Subject: Dresden Station Unit 3  
 Supplement A to Reload 4 License Amendment  
 to Facility Operating License No. DPR-25  
 NRC Docket No. 50-249

SUPPLEMENT A TO DRESDEN UNIT 3 RELOAD 4 LICENSING AMENDMENT

VOID COEFFICIENT

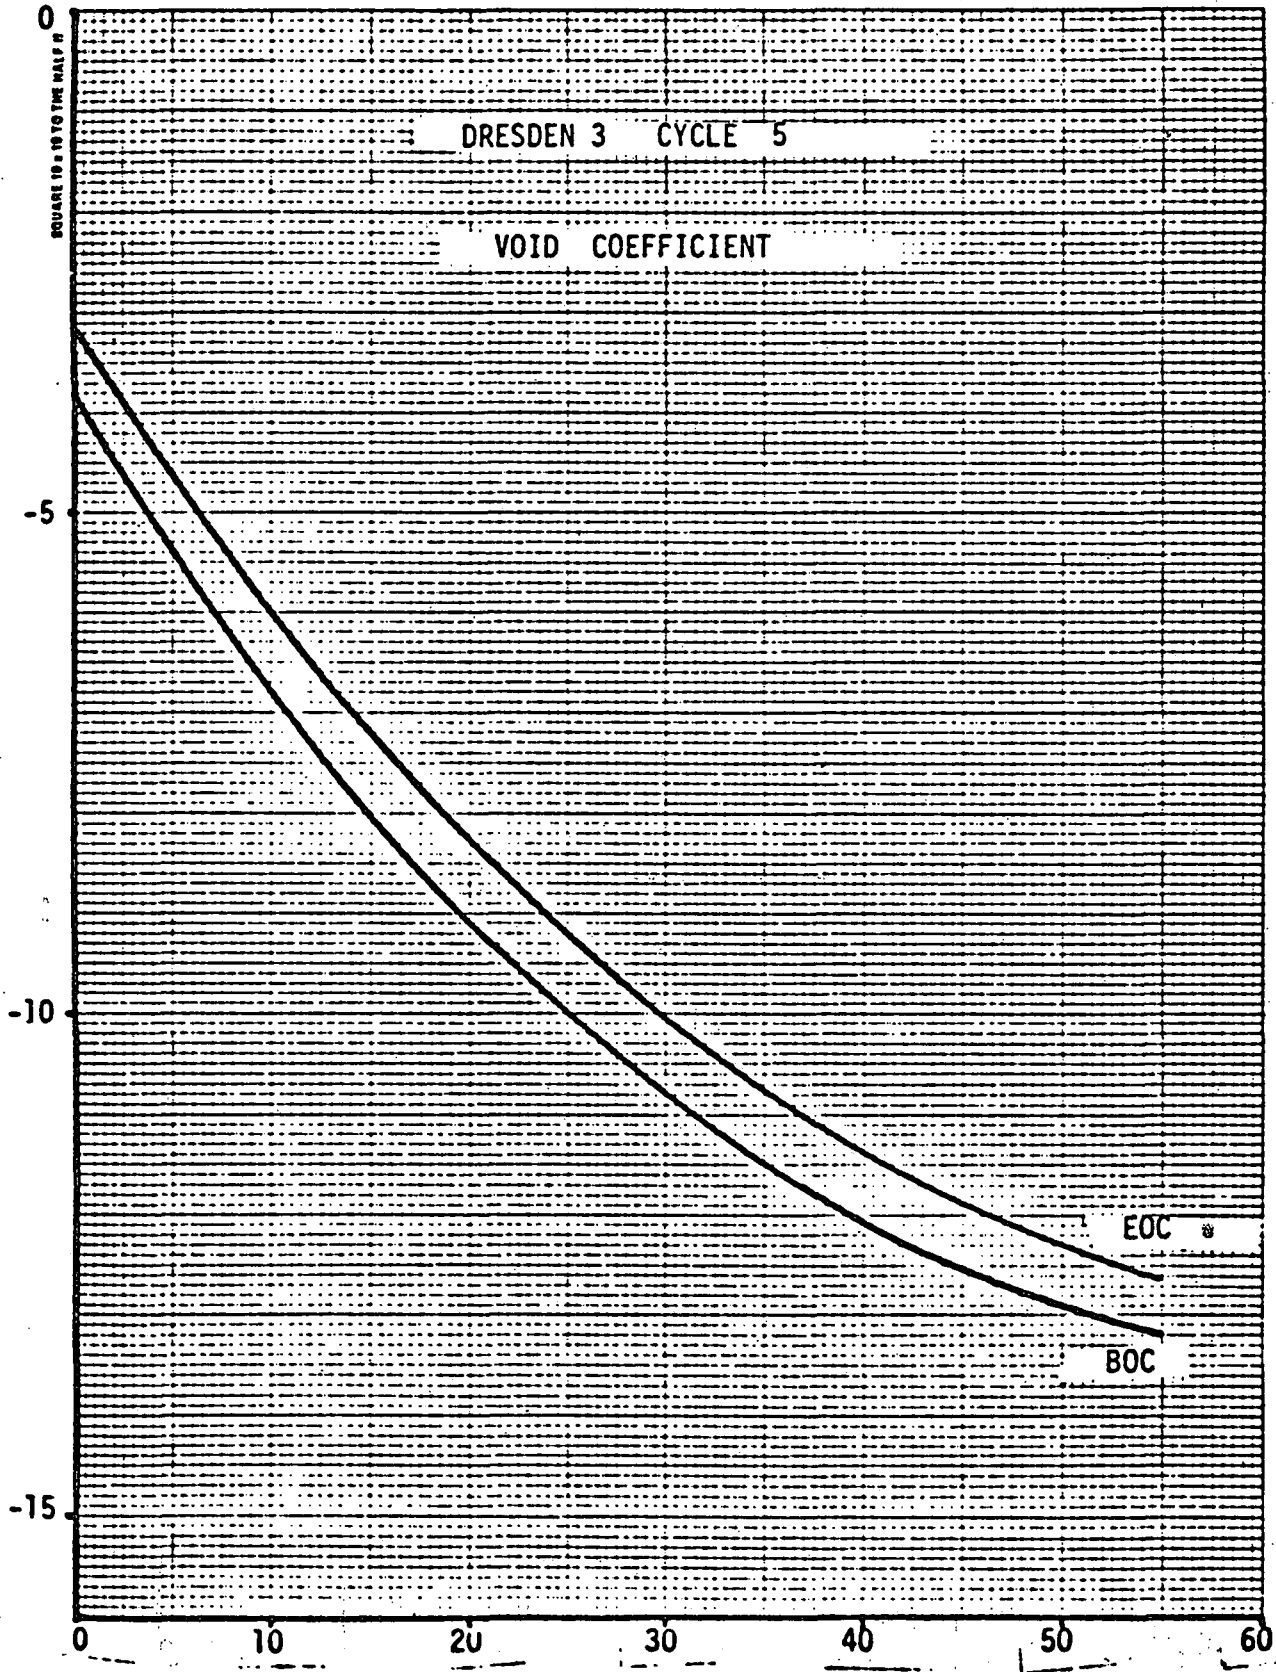
QUESTION 4: Provide curves (for BOC and EOC) of the void coefficient of reactivity as a function of void fraction.

RESPONSE 4: The curves are provided in the attached void fraction figure.

Figure 6-6. Scram Reactivity and Control Rod Drive Specification Dresden 3 Cycle 5

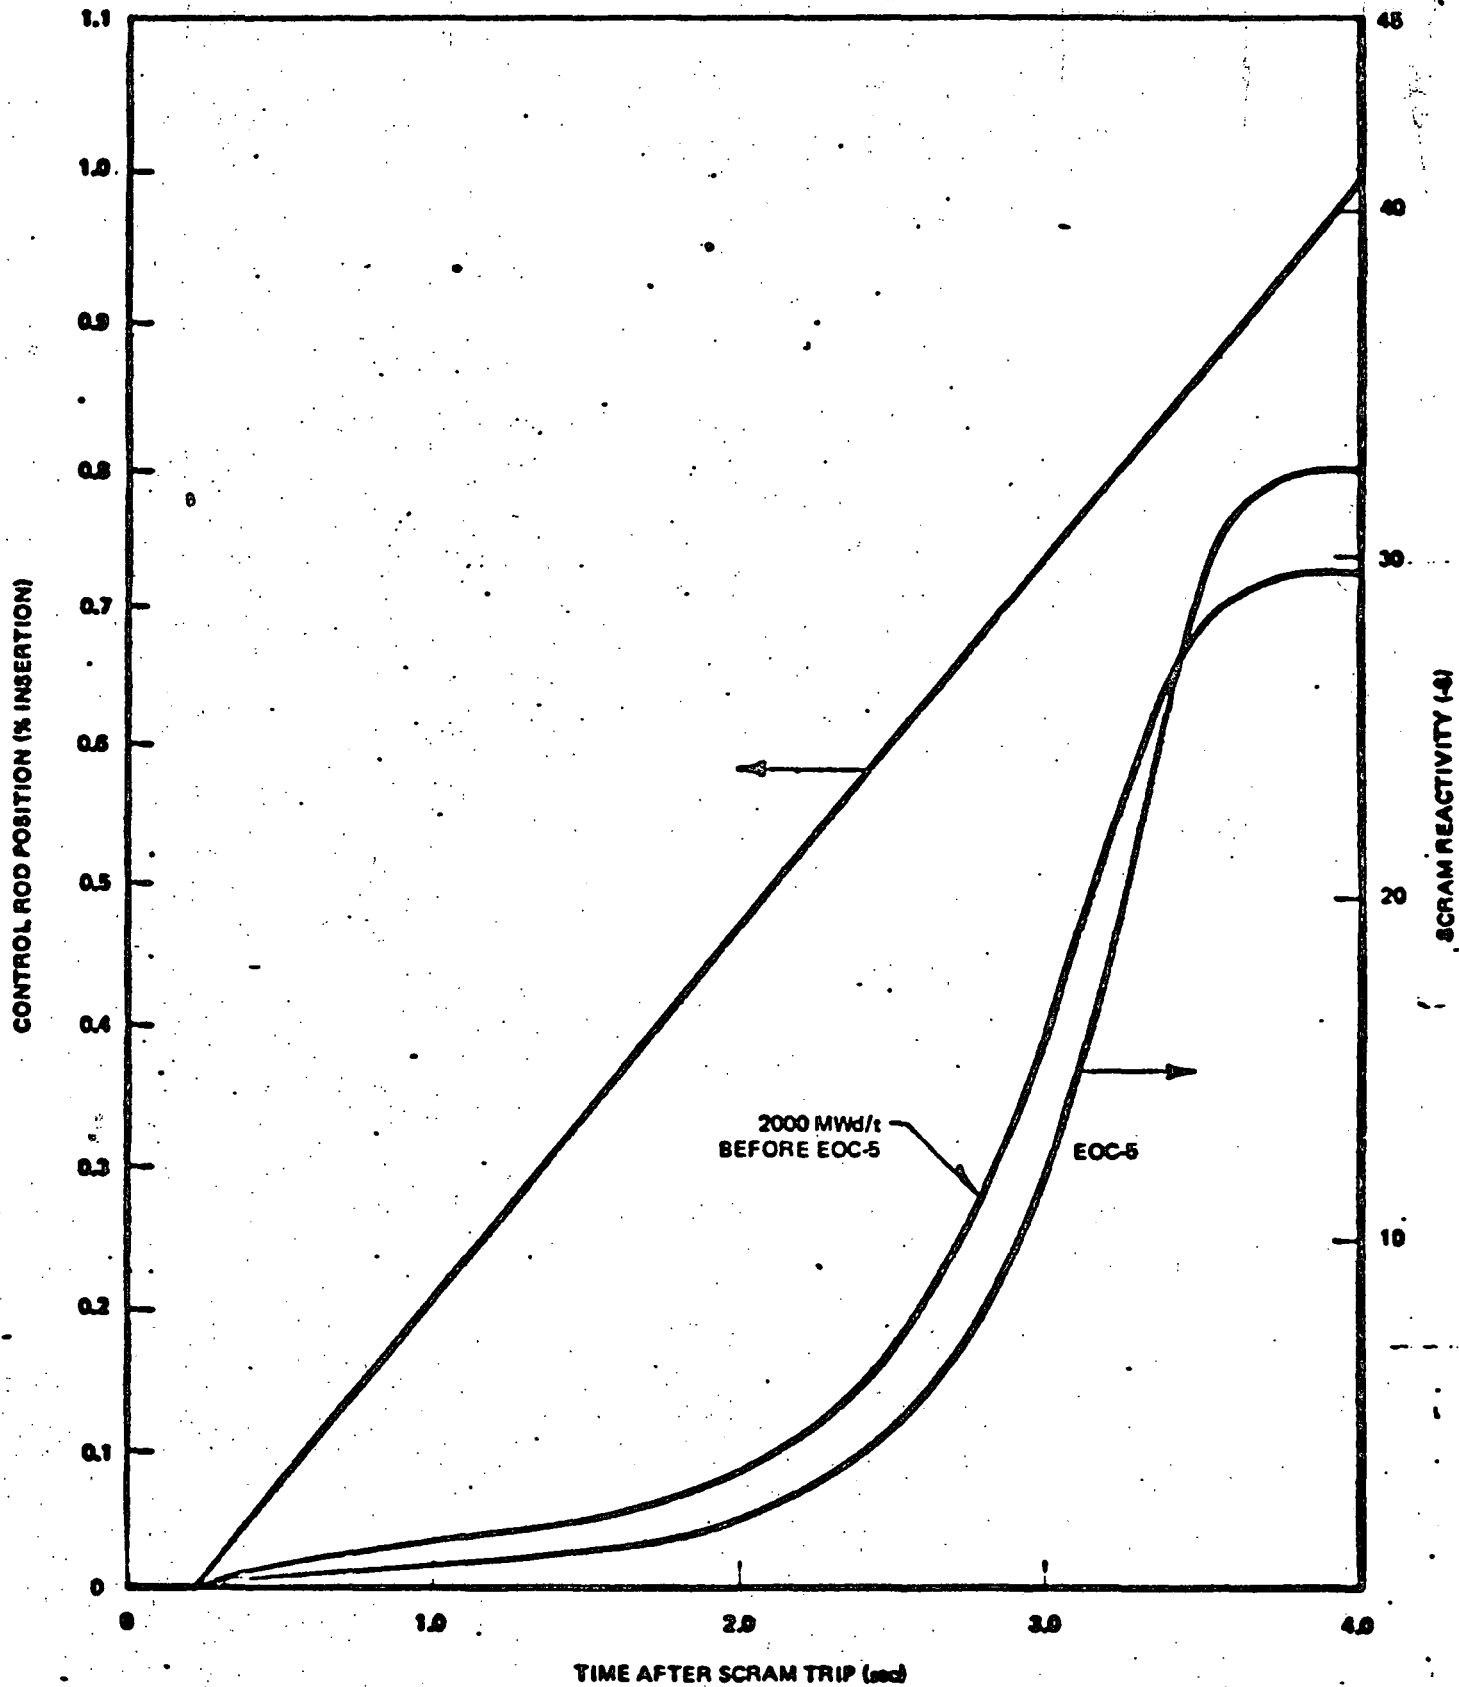
QUESTION 5: Figure 6-6 of NEDO-21338 shows scram reactivity curves labeled EOC 3 and 1500 Mwd/t before EOC 3. Explain why cycle 3 curves apply to Dresden Unit 3 cycle 5. What improvements were made to achieve the scram reactivity curves used for the transient analysis for reload 4? When the scram reactivity curve is utilized as a transient input parameter, what conservative factor is applied to the design scram reactivity curve.

RESPONSE 5: These scram curves are incorrect. The Quad Cities 2, Reload 2 scram curves were inserted in error and will be replaced by the correct scram curves. A safety conservatism factor of 0.80 is applied to the applicable scram reactivity curve.
